Appl. No. 09/590,586
Response Dated Aug. 6, 2003
Reply to Office Action of 6/9/03

Responses to Examiner's Remarks in Detailed Action

PROPOSED DRAWING CORRECTIONS

FIGURE 4

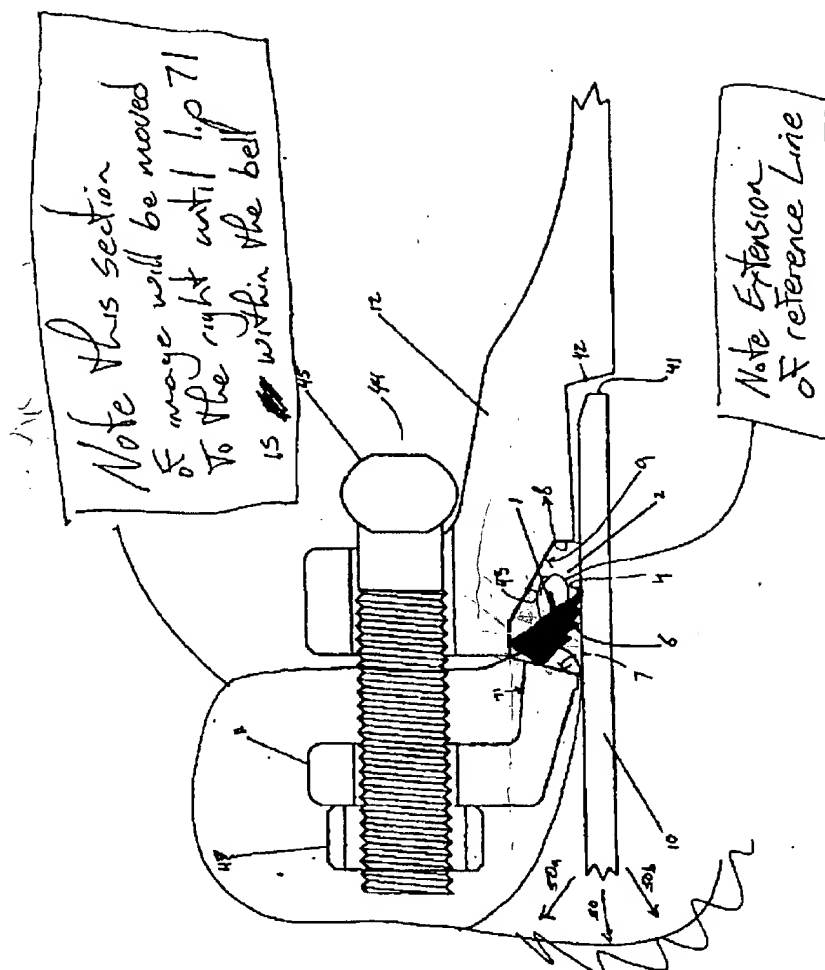
2. The Examiner requires showing of the "lip being at least partially within" the female pipe portion. As shown in the attached annotated drawing correction, Applicant has revised Figure 4 to show the compression gland advanced by tightening of the bolts, which renders the lip within the bell of the female pipe. Support for this change is present in Figure 7 (which shows the lip within the bell, in a different embodiment) and at paragraph 5 of the Specification as filed.

3. The Examiner requires correction of the use of reference character "1," which appears in the unamended drawings to refer to both the locking segment and to portions of the gasket 2. Applicant has corrected this error by removing reference character 1 and its lead line from Fig. 1, and by extending the lead line in Fig. 4 to more clearly designate the segment.

The Examiner objected to Claims 2, 4-11, and 16 because it was unclear from Figures 1-6 how the lip of the gland was partially within the female pipe portion. Applicant's amendment to Figure 4, as discussed with the Examiner on August 5, 2003, clarifies this issue. Figure 7 as originally filed also shows the lip within the female pipe. Finally, with regard to Claim 16, Applicant has amended the Claim to specify that it is only the lip of the gland that is said to extend partially within the female pipe.

*Drawing changes not
 approved
 by
 Examiner
 11/4/03*
